Engineering Change Notification

Product Change of Sleeve QM series

Project No
242 843

Project Title
QM series

Fig .1

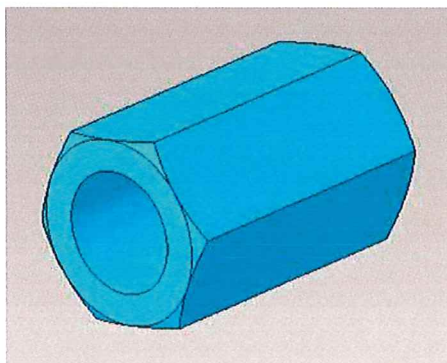
There are small differences of housing surface (color anodizing) between the "previous/blue anodizing" and "future/neutral anodizing" versions.

“blue anodizing”

Fig. 2

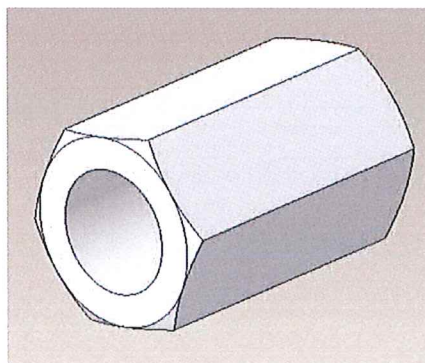
“neutral anodizing”
